**DEVELOPMENT APPLICATION DA 2020/0816  
23-33 BASSETT STREET MONA VALE  
PROPOSED RESIDENTIAL CARE FACILITY UNDER SEPP HOUSING  
FOR SENIORS**

This document is a submission by way of objection to Development Application 2020/0816 (the 'development application') relation to Nos 23 - 33 Basset Street Mona Vale (the 'subject property').

**Figure 1-** North elevation showing west boundary of site and relationship with adjoining cottage style development

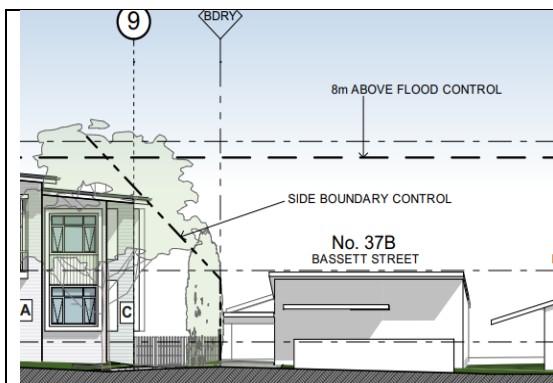
This site is not in a medium density residential zone nor is the property located in a mixed use commercial type environment. The fact that the site is zoned for 'low density residential' purposes should be instructive to the applicant as far as the development proposal is concerned. This is especially the case where low density residential extant development is to be replaced by a high density facility (over the eastern part of the land). We contend that the architect has failed to take into account the reasonable expectations of adjoining land owners and occupiers in this regard. Figures 1 and 2 below show the relationship between the proposal and adjoining development to the east and west (source Gartner Trovato Architects). In our opinion the separation between the built elements in Figure 1 is not acceptable.

In our view the building should be broken into at least two built elements crossways, so that some respect can be paid to the built form of existing cottages in other parts of this streetscape (with their narrow frontages), the relevant low density zone and the PDCP character statement suggesting that vegetation should be integrated with development. In this case the reduced street setbacks will not allow for sufficient planting to soften this bulky and very lengthy facade.

**Figure 2-** North elevation showing east boundary of site and relationship with adjoining cottage style development

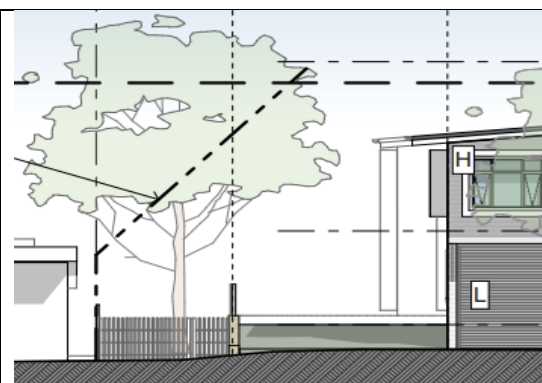
We note that the proposed floor space ratio (FSR), which is set at 0.95:1 means that in this case, given the restricted height, a very squat disproportionately lengthy built form of around 95m will result. Further however, the building is excessively bulky and is not satisfactorily relieved and articulated when viewed from the street frontage and both the east and western boundaries. From the south, the significant setback means that the bulk and scale will be a far less critical issue, in terms of the public domain or amenity.
